Sydney Dance Company
The Wharf, Pier 4
15 Hickson Road
Sydney NSW 2000

Re: Walsh Bay SSDA, Letter of Support and Sydney Dance Company Issues

Precinct stair orientation precedent

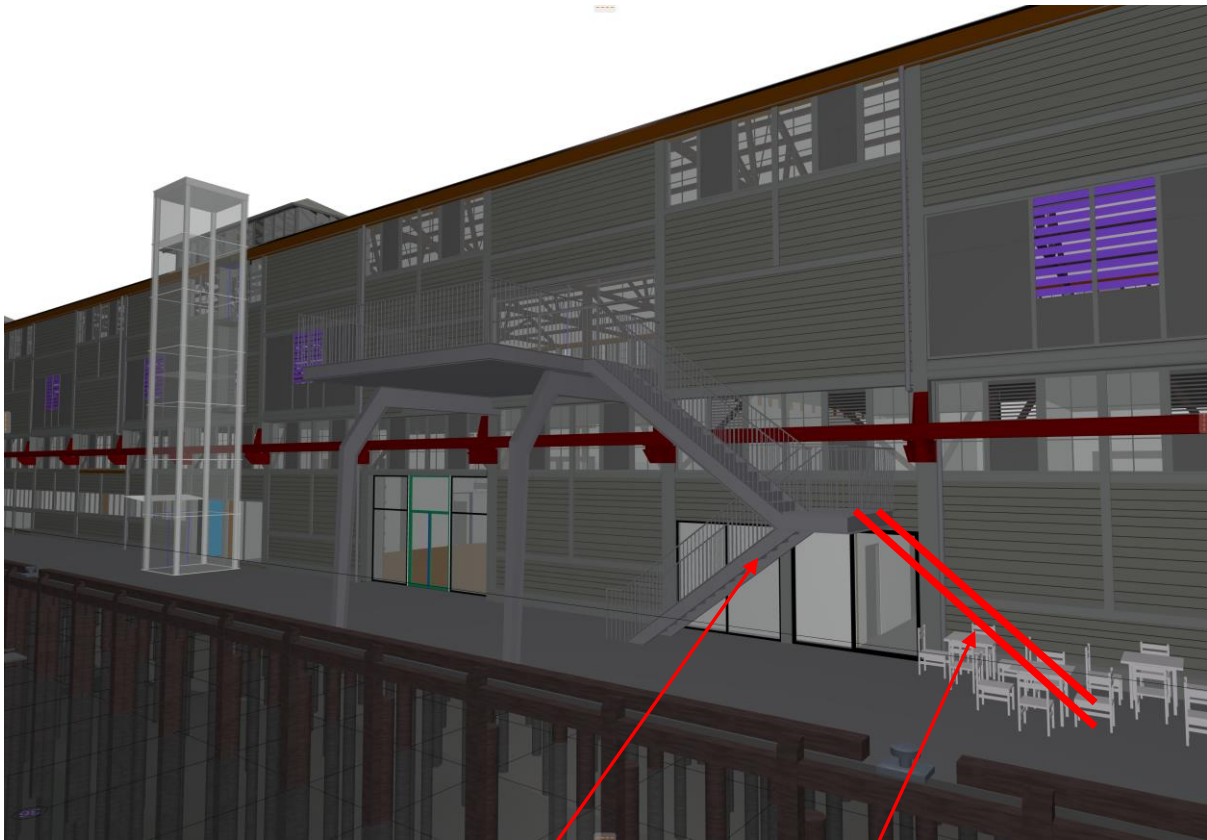
SDC is very concerned the inclusion and use of this new stair (grid 31-33) will significantly restrict access to the new Studio 5, the use of the adjoining apron area and generated noise impacting on performances and other activities in Studio 5. It would appear STC patrons will use the balcony and stair to access the theatres and more critically, exit STC premises directly via the stair resulting in large volumes of people moving past the Studio 5 entrance.

SDC proposes the stair be reconfigured from the switchback style to a straight stair with landing such that access/egress would be to north, not outside studio 5. A review of other access structures in the precinct indicates a variety of designs, including the style proposed. Please refer to the attached sketch and photograph for as a proposed solution.

Remove
stair

Reconfigured
STC stair access
